Victoria Point Manchester

NMA - Design and Access Statement Addendum
Blocks 5 and 6

Addendum to Planning Application

This document has been put together to support a non-material amendment to the Victoria Point planning application ref 139987/FO/2024.

Ground Floor Plan

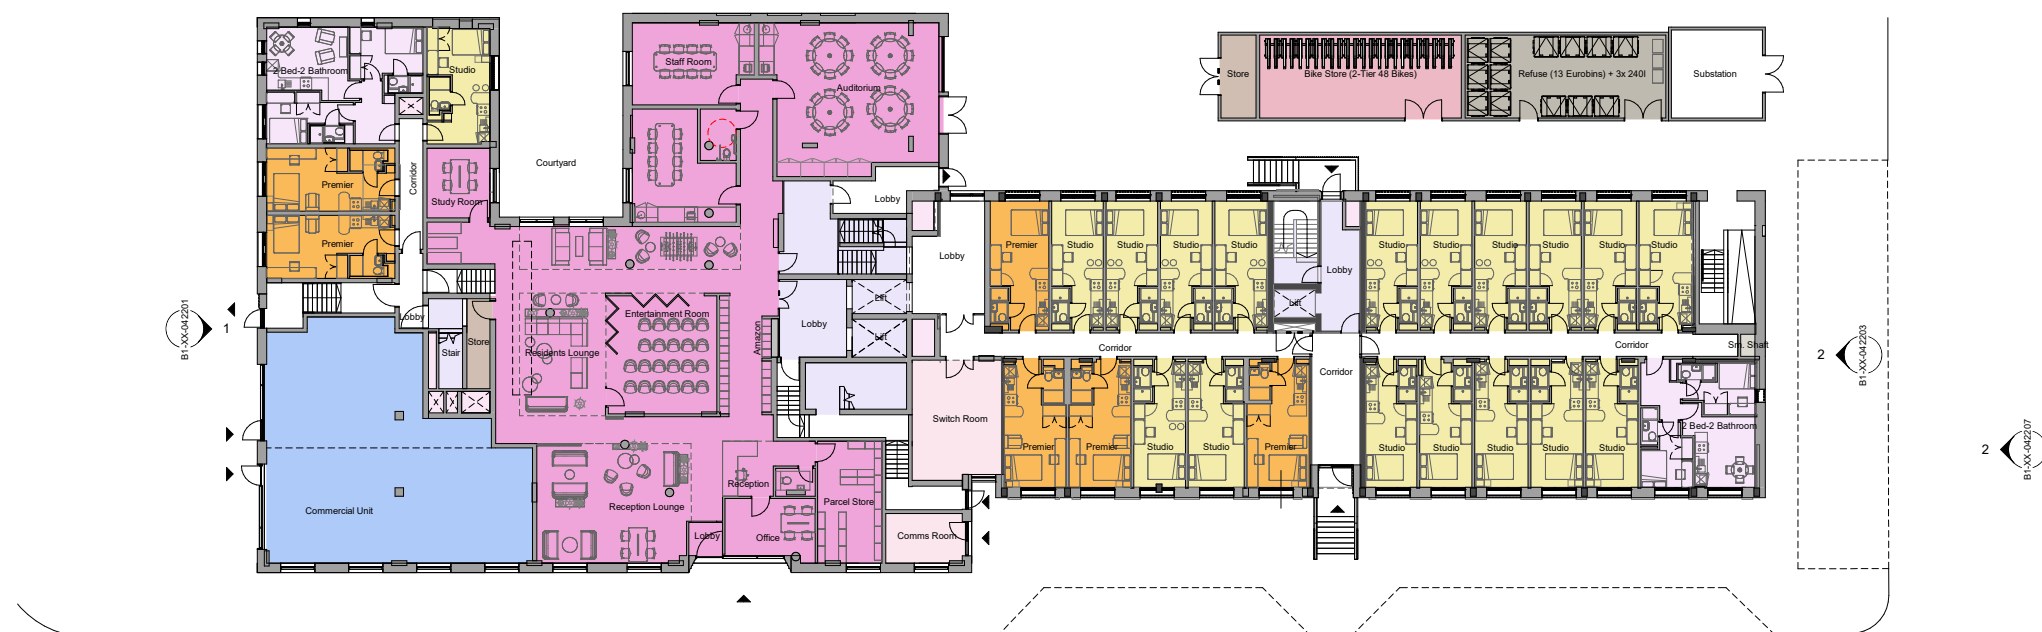
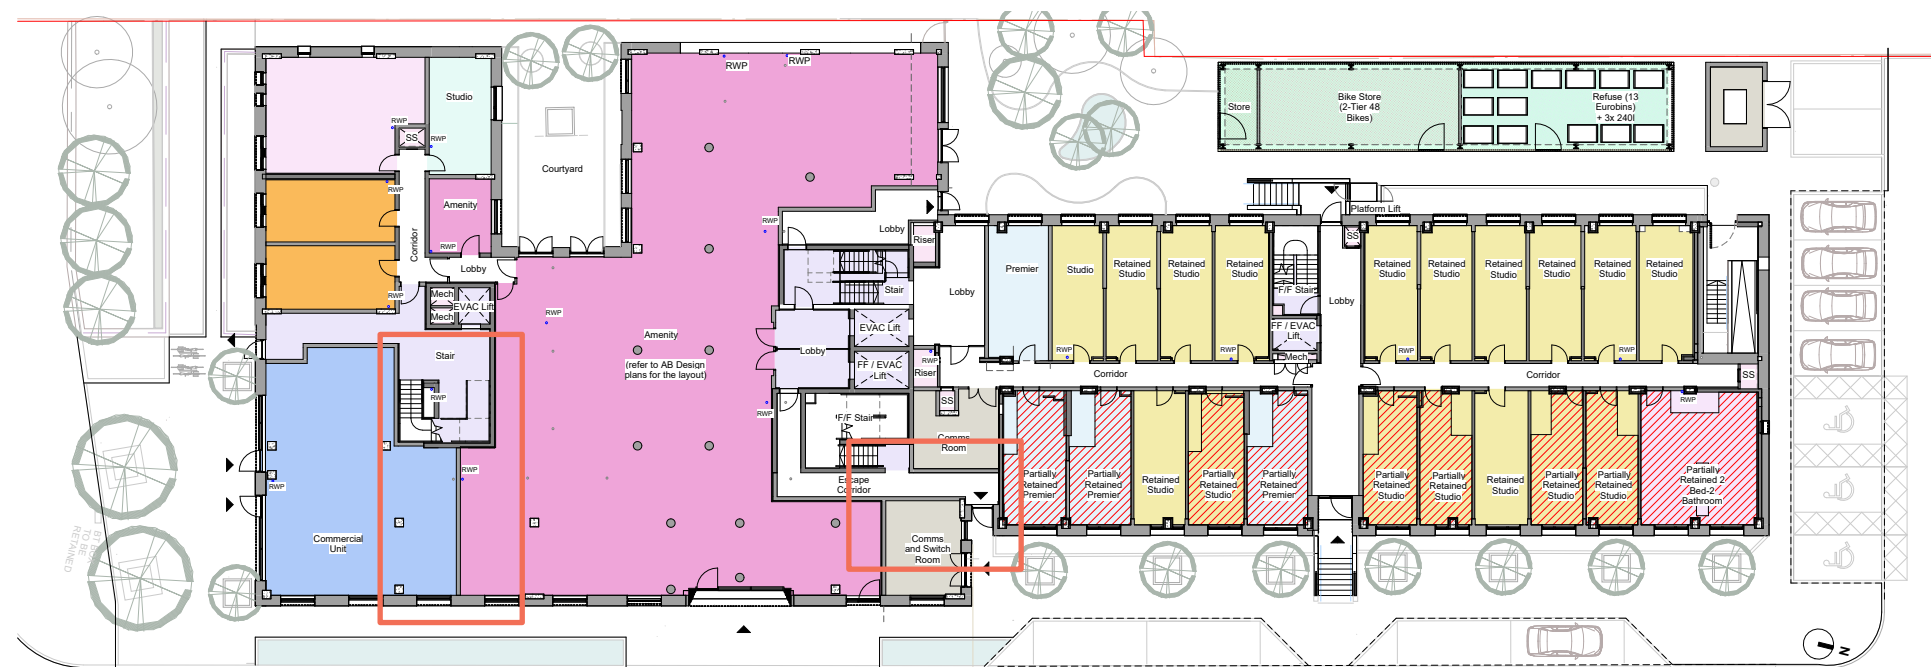
The ground floor plan has been updated to allow for changes to the cores as a result of updates to Fire Safety Standard BS9991:2024. This has resulted in the rerouting of the escape exit from the central core and a reduction in size to the commercial unit facing Hathersage Road, from 145 sqm to 115 sqm.

Proposed First Floor Plan (indicative of first to fifth floor changes)

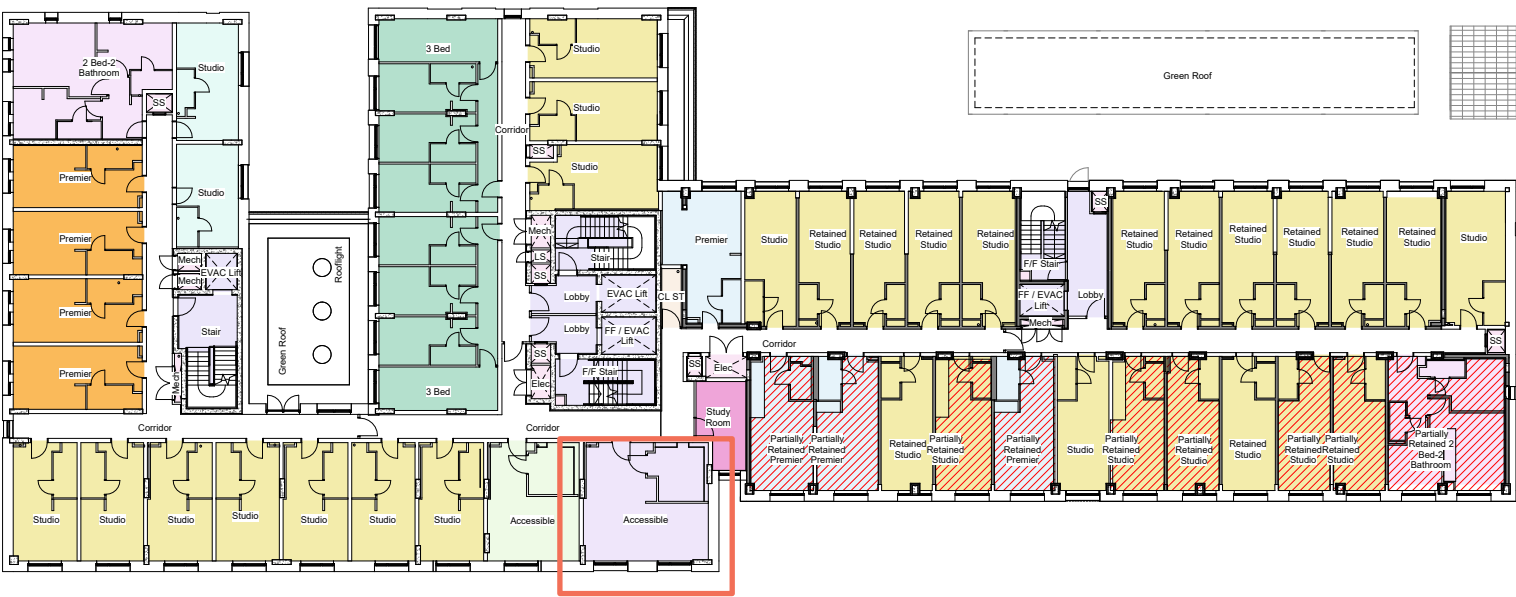
In order to meet the requirements for accessible studios across the campus, 5 No. additional accessible studios have been added to Block 6, by replacing 4 No. 2 bed studios and 2 studios and 2 No. studios, resulting in a reduction of units from 304 to 303, and a reduction of bedspaces from 365 to 360 for Blocks 5 and 6.

The first floor plan shows where the new accessible studios are located - this is repeated from first to fifth floor.

South and East Elevations

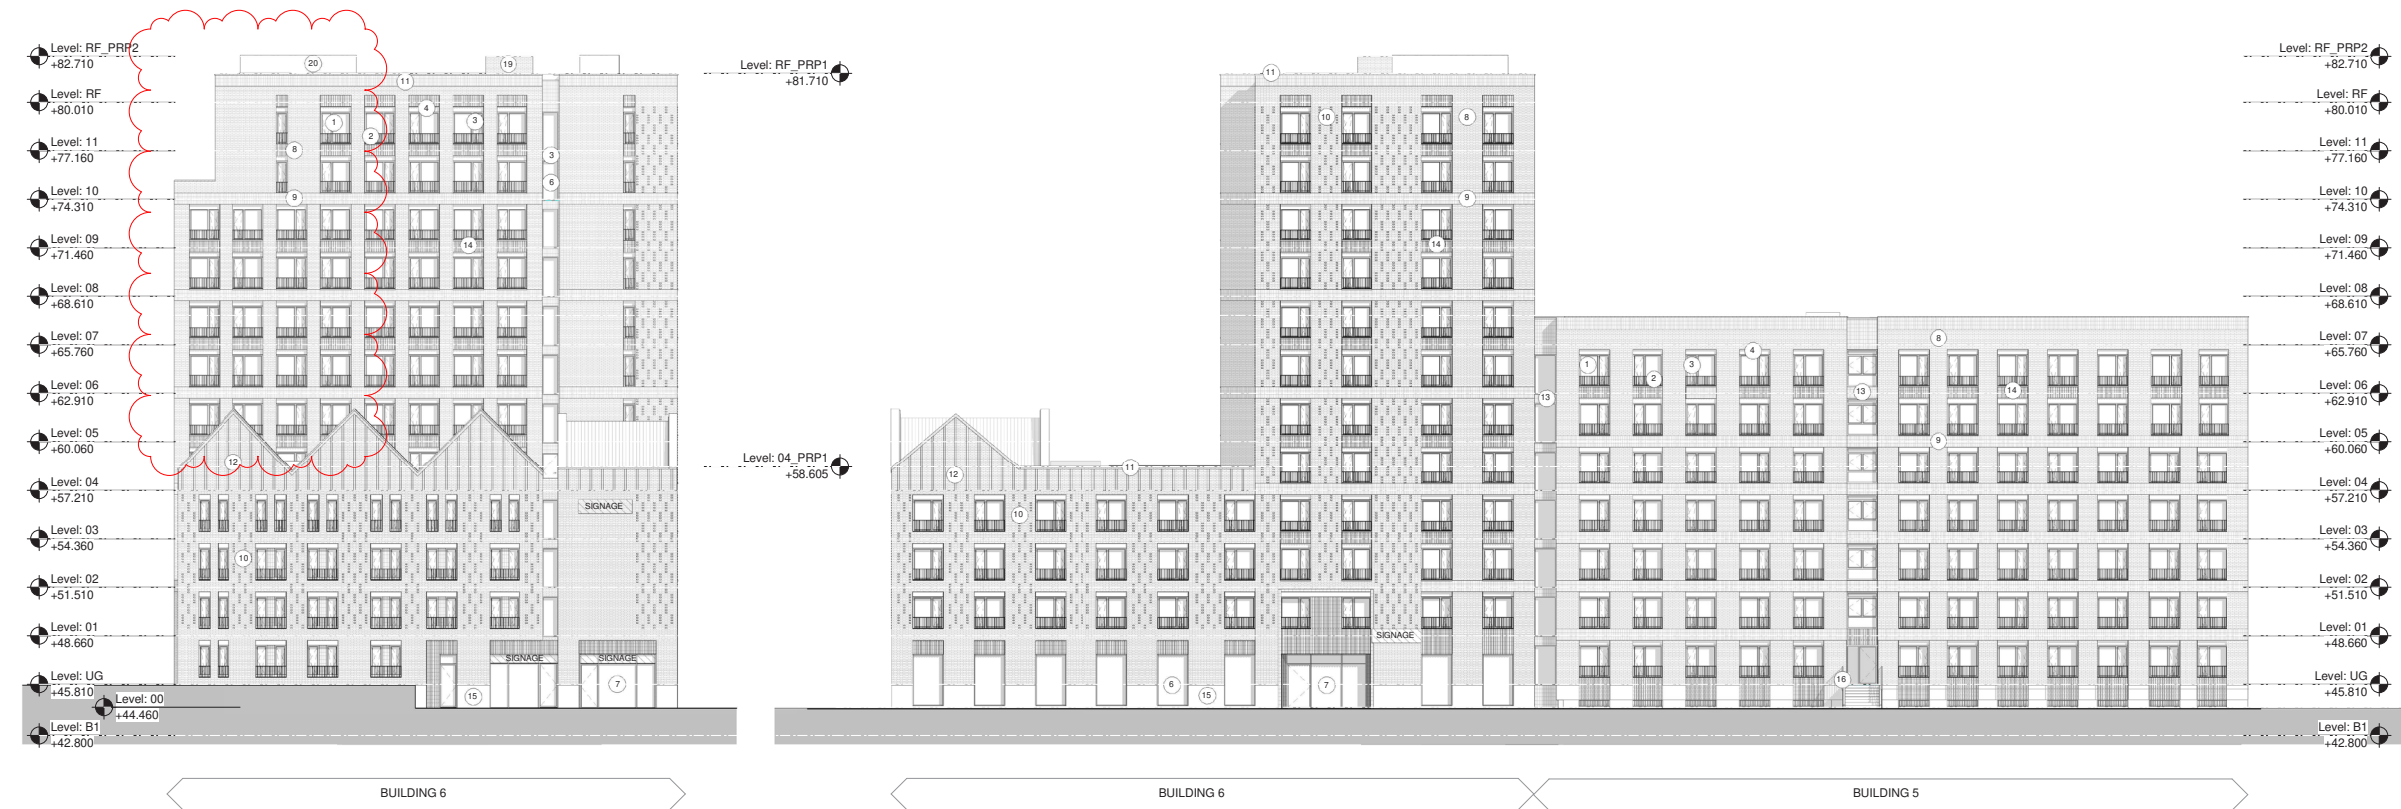
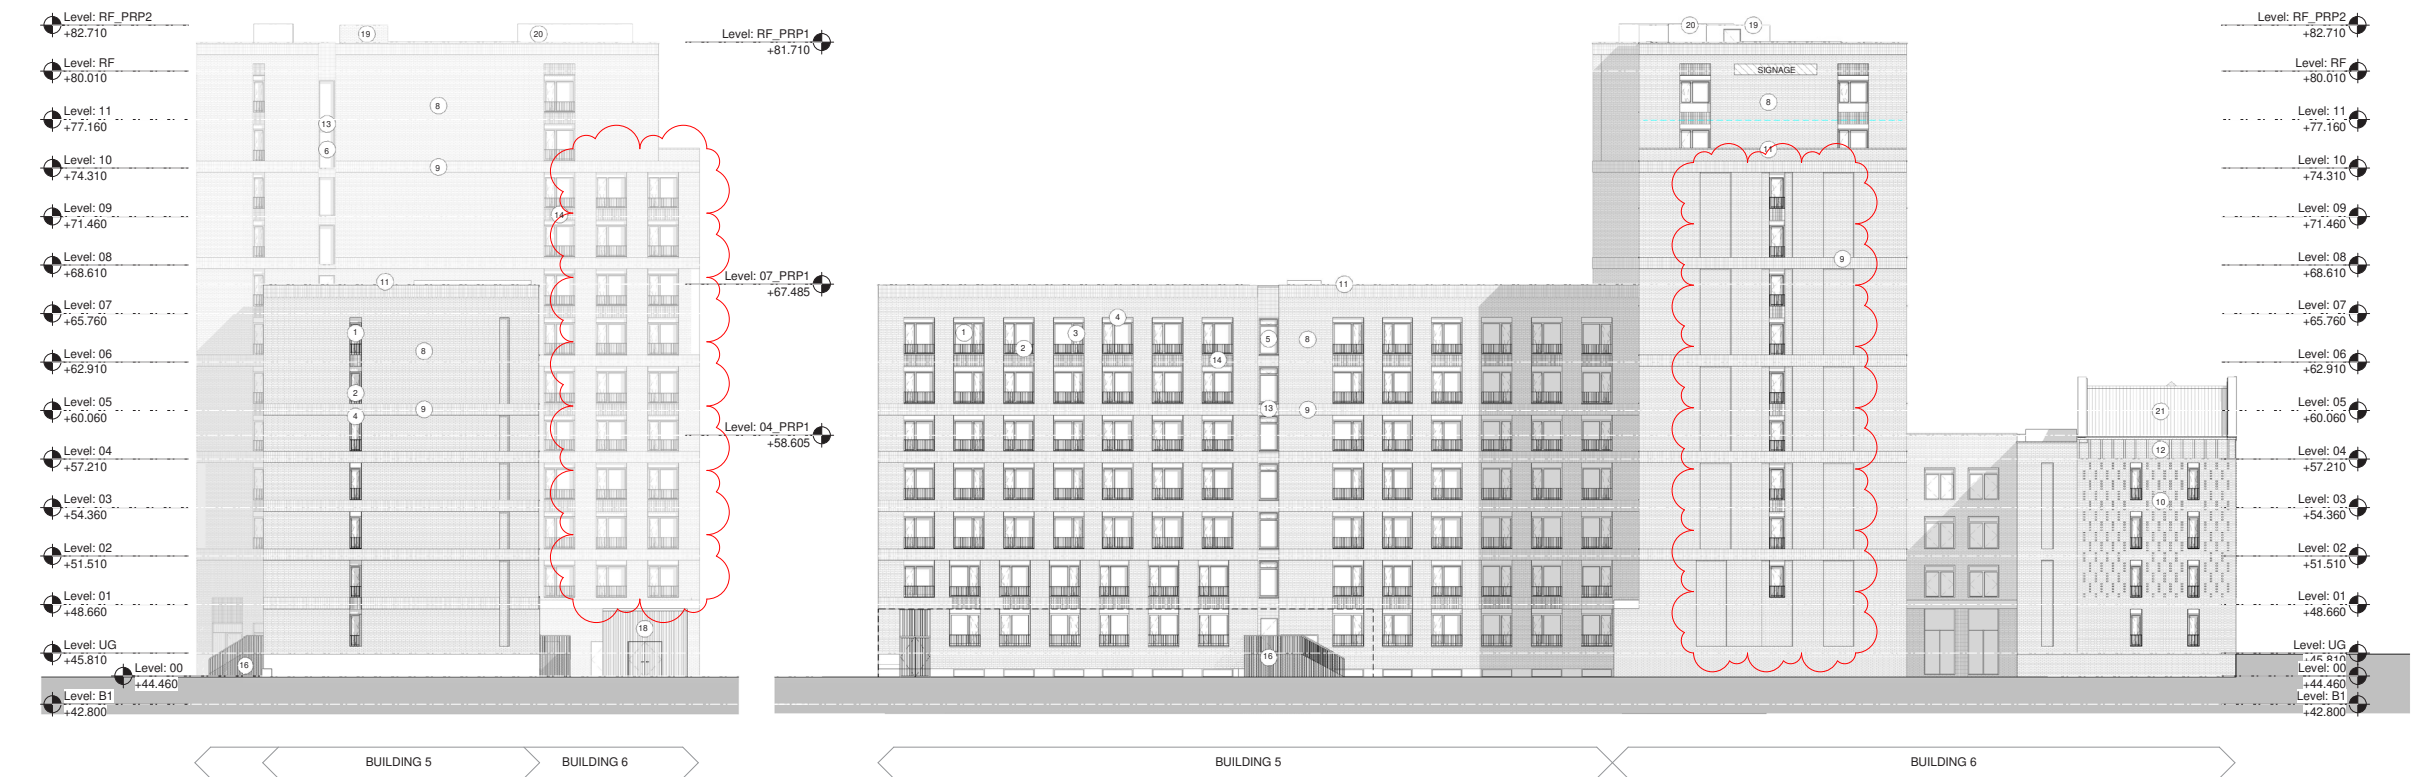
A number of minor elevational changes have been made to accommodate design development, most notably due to structural requirements and updates to fire safety standard BS9991:2024

- 1. Windows lowered due to lower floor level at ground floor to account for changes to Hathersage Road core
- 2. Louvres added to commercial space and amenity space
- 3. Door added to parcel store
- 4. Door altered from fire exit
- 5. Windows altered (position and design) to account for existing structure
- 6. Pitched roof reduces at rear to allow access to plant

North and West Elevations

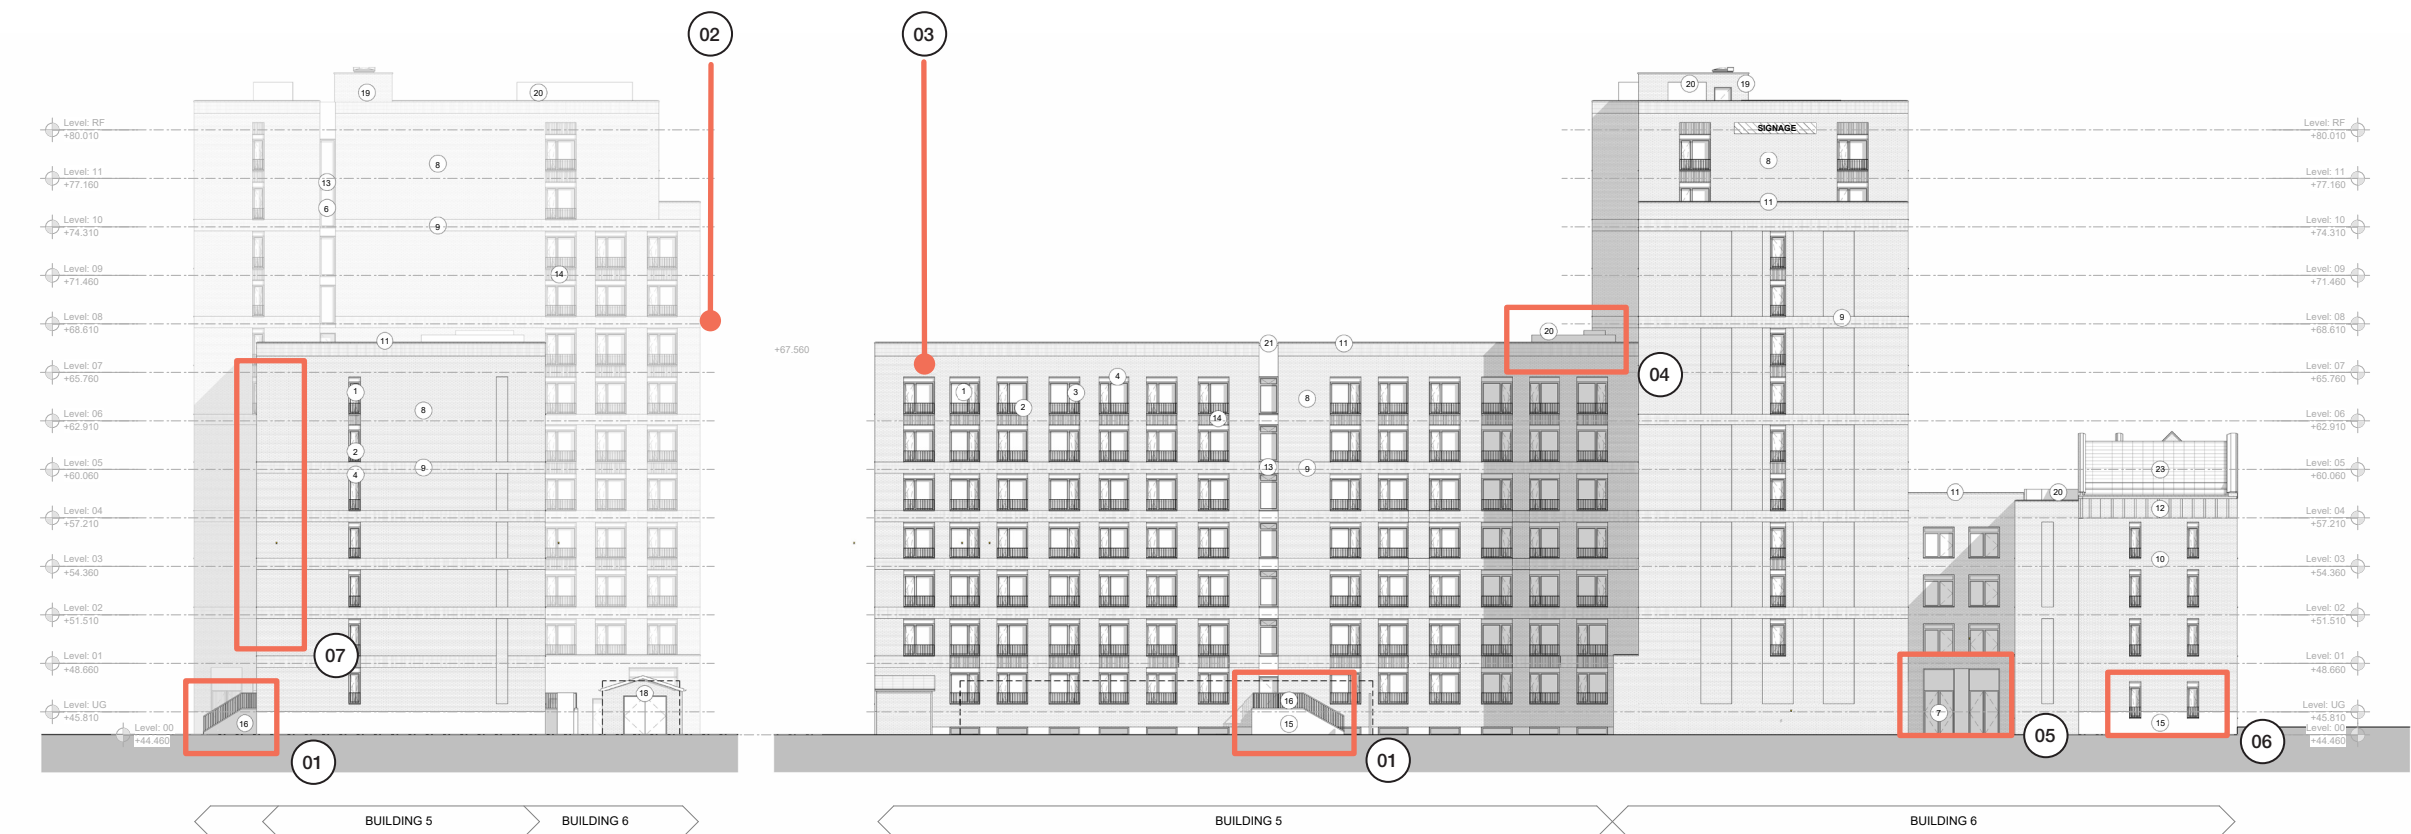
A number of minor elevational changes have been made to accommodate design development, most notably due to structural requirements and updates to fire safety standard BS9991:2024

- 1. Stair design altered to reveal concrete base
- 2. Parapet raised by 75mm to Block 5 to allow safe parapet height
- 3. Window positions altered slightly to account for existing structure
- 4. Generator relocated
- 5. Door openings into courtyard shown
- 6. Windows altered (position and design) to account for existing structure
- 7. Windows removed to accessible studios
